N61165.AR.005051
CNC CHARLESTON
5090.3a

FASCIMILIE TRANSMISSION FOR WELL INSTALLATION NOTICE CNC CHARLESTON SC
04/11/1990
KEMRON ENVIRONMENTAL SERVICES, INC

Monitoring Well Approval

RE: Chicora Tank Farm
Charleston County

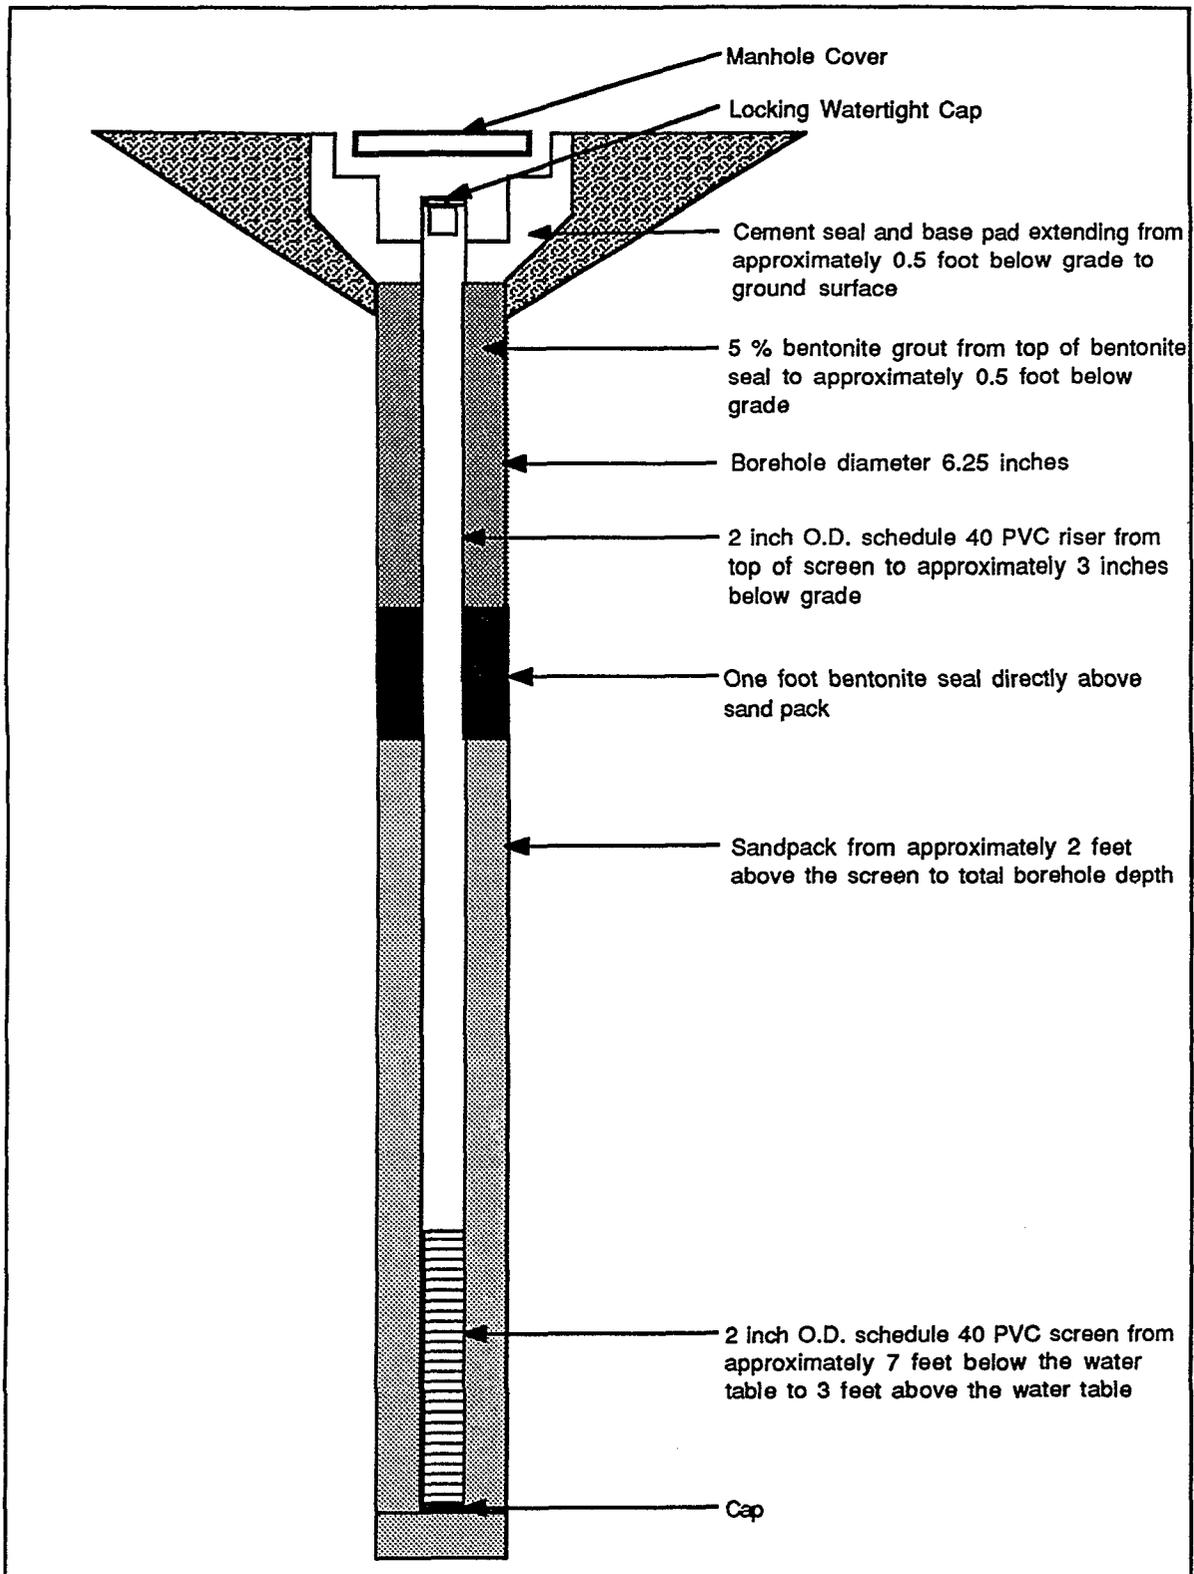
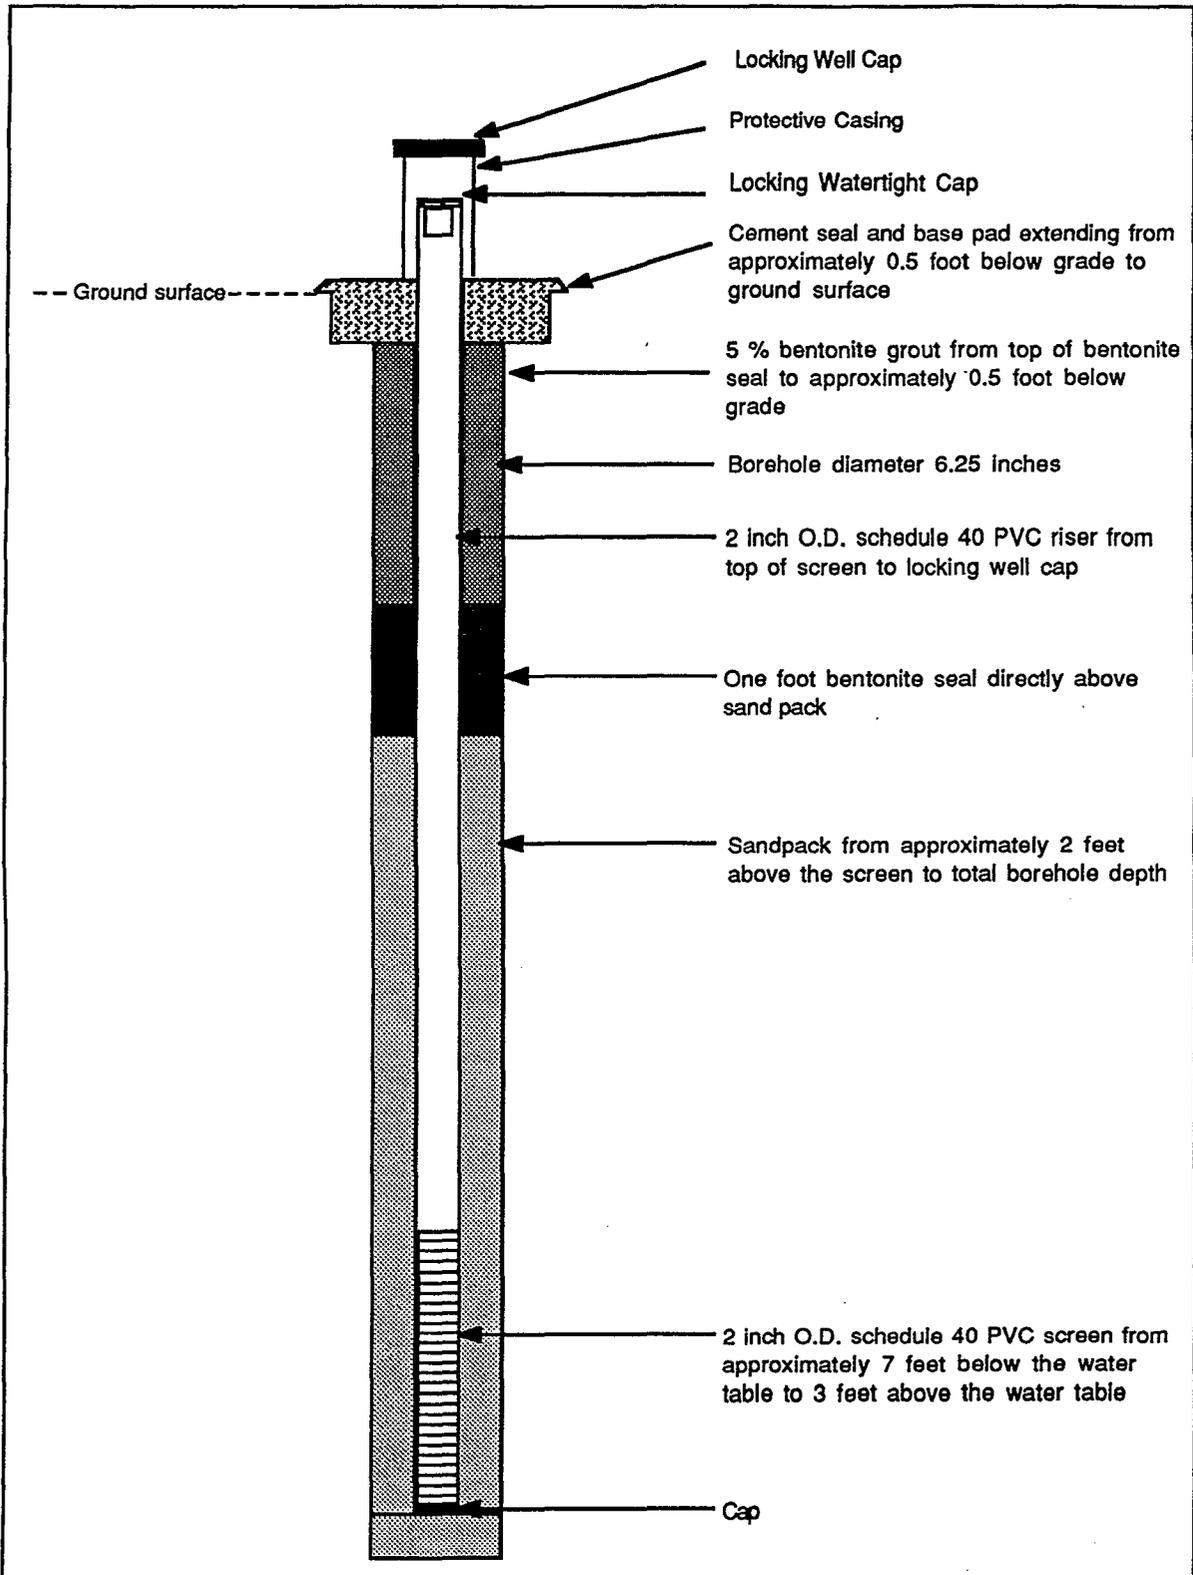
for the construction of monitoring wells designated MW-1 to MW-11
in accordance with the construction plans and specifications
submitted on April 16, 1990.

These wells will be constructed to the approximate depth of 15 feet
below the surface and screened in the surficial aquifer for the
purpose of monitoring ground-water quality.

Conditions: That the latitude and longitude and actual
construction details for each well be submitted within 30 days
after installation. That the analytical results be submitted
within 30 days of receipt of laboratory results.
